UNIVERSITY OF VIRGINIA
DEPARTMENT OF NUCLEAR ENGINEERING AND ENGINEERING PHYSICS
NUCLEAR REACTOR FACILITY
SCHOOL OF ENGINEERING AND APPLIED SCIENCE
CHARLOTTESVILLE, VA 22901

December 13, 1984

U.VA. Formal Questions

CAVALIER REACTOR LOADING CHART

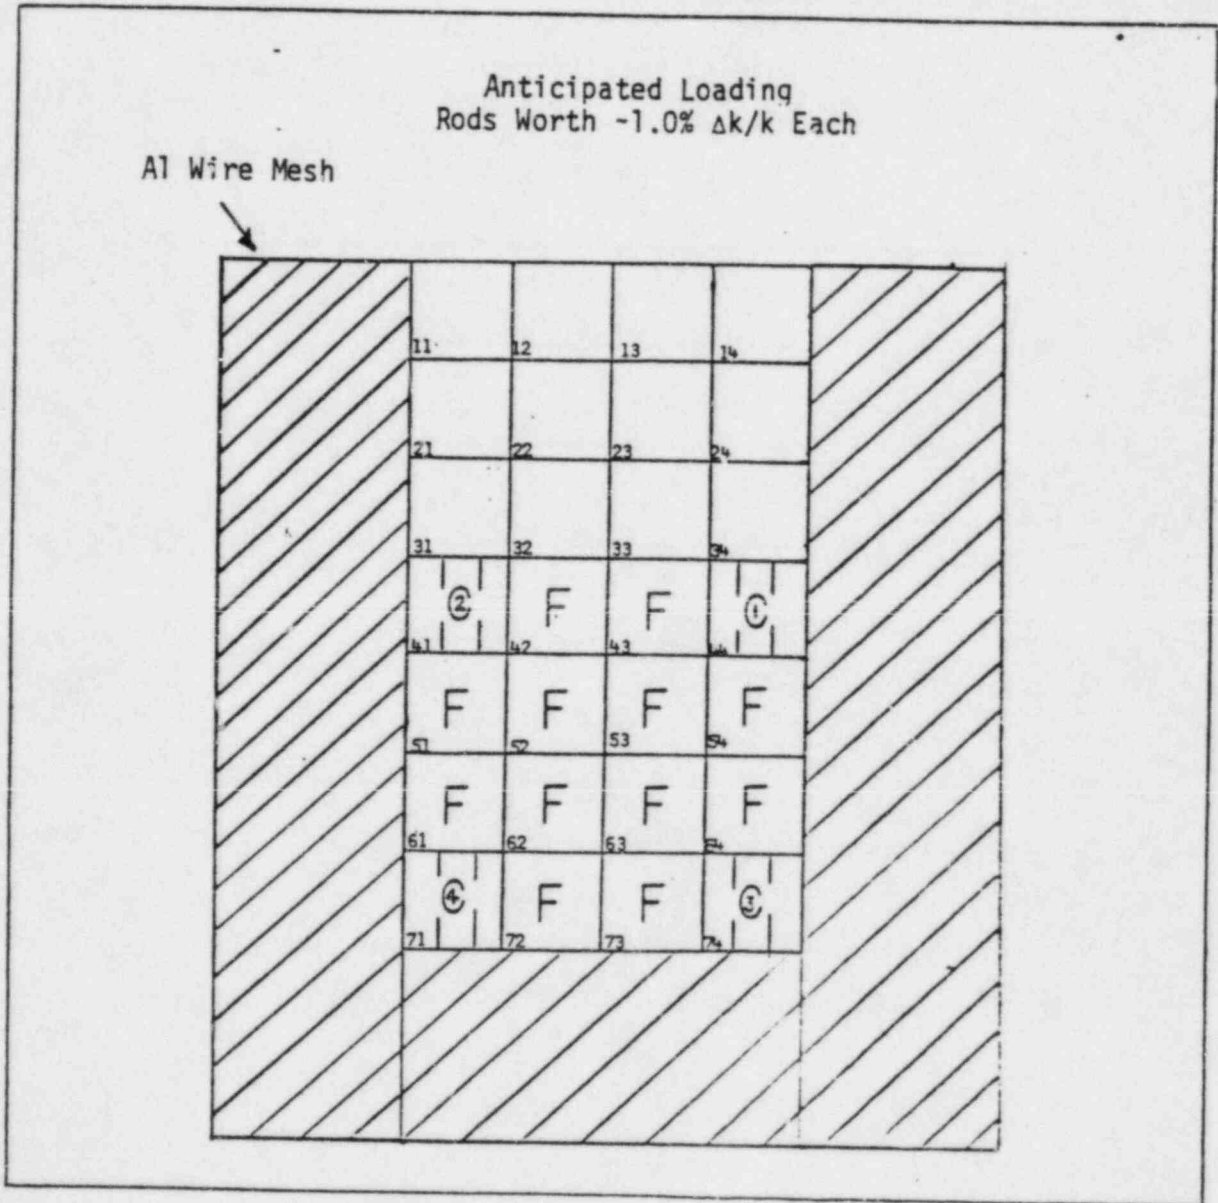
1. Question: When the CAVALIER is again loaded with fuel, describe the expected core configuration (number and location of fuel elements, control rods, and graphite or aluminum reflector elements). What is the total expected U-235 inventory in the CAVALIER core?

The expected core configuration for the CAVALIER reactor is a 4x4 array of fuel elements with the control rods at the four corners, water reflected, with an aluminum wire mesh around the core to prevent any movement of objects near the fuel elements (see attached diagram). This is the same configuration that has been used in the CAVALIER for the past 9 years except the previous loading had flat plate fuel elements (approximately 2.2 Kg. U-235) and the planned loading will have curved plate fuel elements (approximately 2.7Kg. U-235). An experimental element with removable fuel plates may be used to adjust the reactivity of the core. The final configuration will be such that it is well within the Technical Specification limits concerning shutdown margin and excess reactivity. The expected worth of each of the control rods is approximately 1.0% $\Delta k/k$, excess reactivity approximately 1.0% $\Delta k/k$ and the shutdown margin with the highest worth rod withdrawn approximately 1.8%.

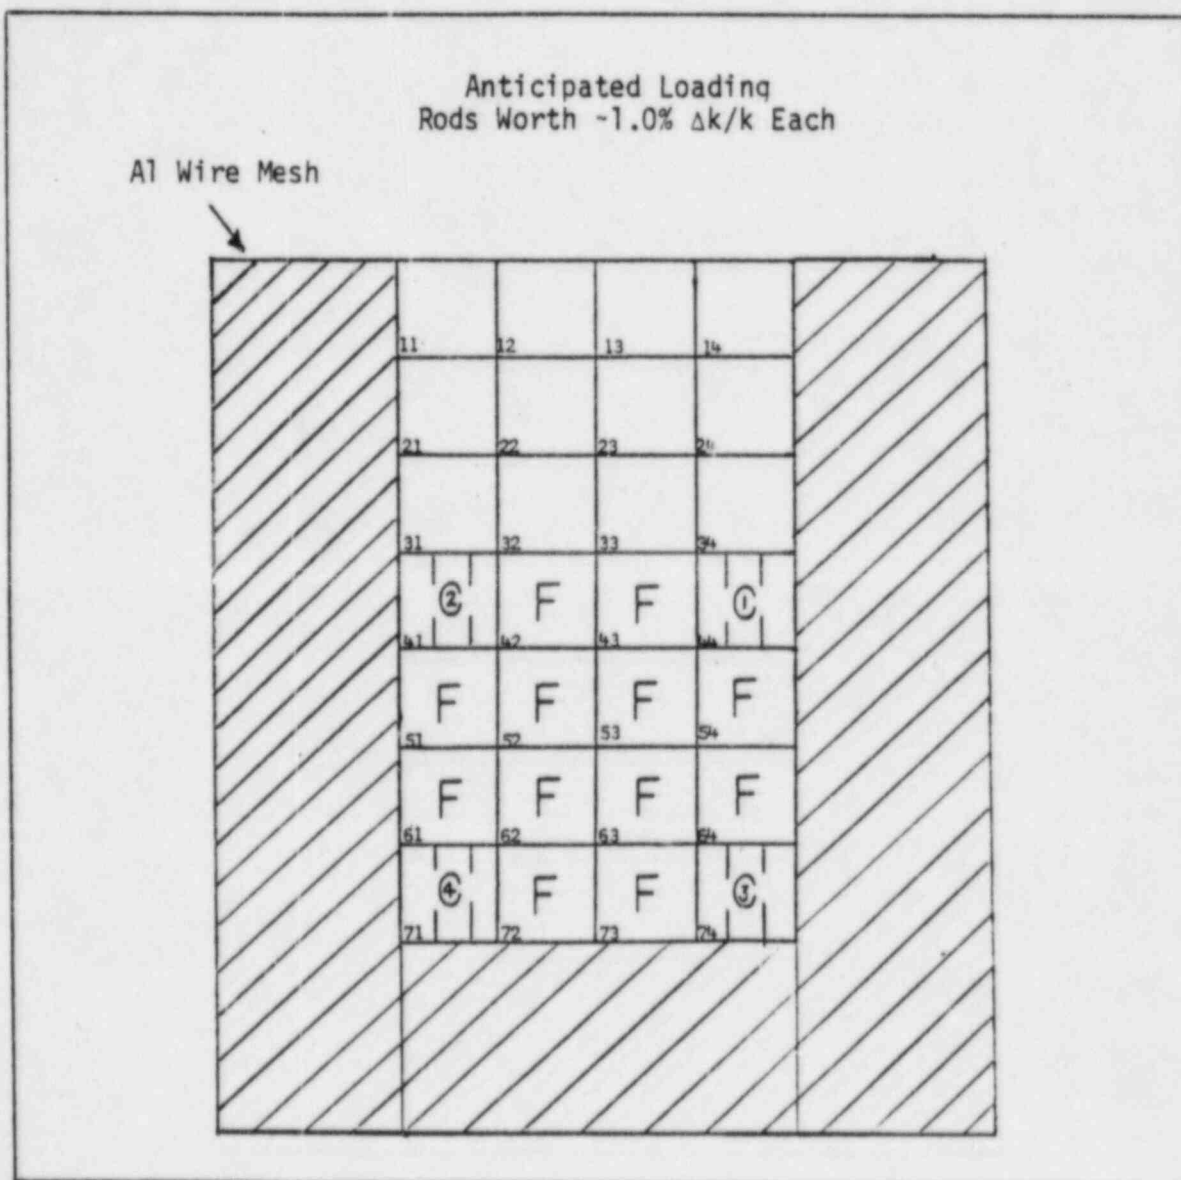
24. Question: Please provide copies of the figures listed in the attachment that will be of suitable quality for use as originals in our Safety Evaluation Report.
- 1) the expected core loading (similar to SAR figure 3.5)
 - 2) a drawing of the standard fuel element in the next core loading
 - 3) same as item 2 for a control rod fuel element.
 - 4) a drawing of a control rod drive unit.

These drawing's are included as part of our response to these questions.
